Docket Number:	09-AFC-05C
Project Title:	Abengoa Mojave Compliance
TN #:	269451
Document Title:	Mojave Solar Project (09-AFC-05C) Staff Analysis for the Petition to Construct Two New Evaporation Ponds
Description:	Staff Analysis for the Mojave Solar Project Petition to Amend to Add Two New Evaporation Ponds (TN 253750, TN 253751, TN 253752 & TN 259278)
Filer:	Ashley Gutierrez
Organization:	California Energy Commission
Submitter Role:	Commission Staff
Submission Date:	4/9/2026 11:57:33 AM
Docketed Date:	4/9/2026

DATE: April 9, 2026
TO: Interested Parties
FROM: Ashley Gutierrez, Compliance Project Manager
SUBJECT: MOJAVE SOLAR PROJECT (09-AFC-05C)

CEC Staff Analysis of Petition to Amend the Final Commission Decision

**Executive Summary Figure 1
Proposed Location of the Two New Evaporation Ponds and Monitoring Wells**

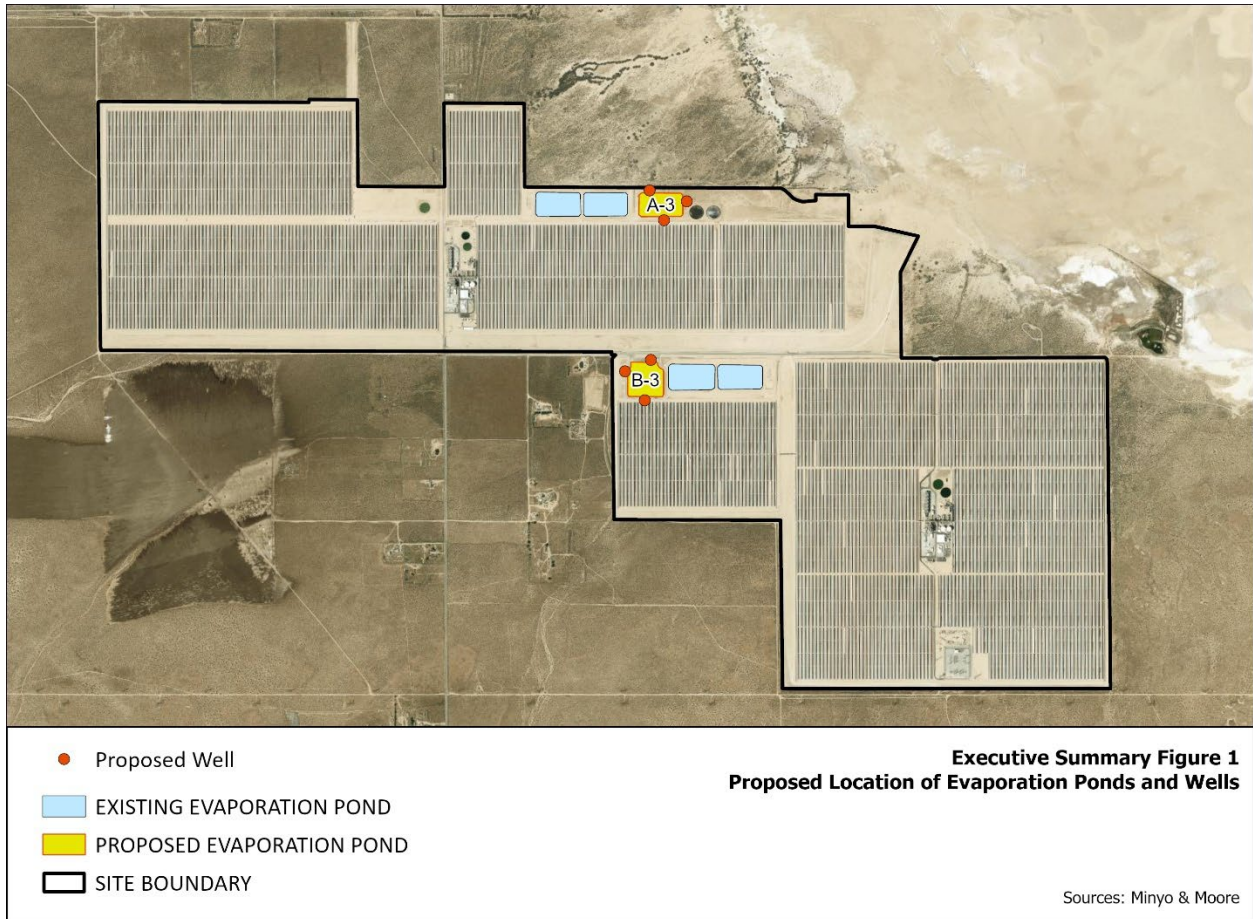
- Ponds would be roughly 250,000 square feet
- The depth of each pond would be nominally 10-feet, which includes the 2-feet of freeboard
- A 40-mil HDPE lower geomembrane, interstitial leak collection geonet, and upper 60-mil HDPE geomembrane
- A leak detection sump, piping, and manhole system
- Neutron probe test pipes and ground water detection monitoring wells; and
- Six new groundwater monitoring wells (three at A-3 and three at B-3).

Executive Summary Figure 1 shows where the new evaporation ponds and monitoring wells would be located.
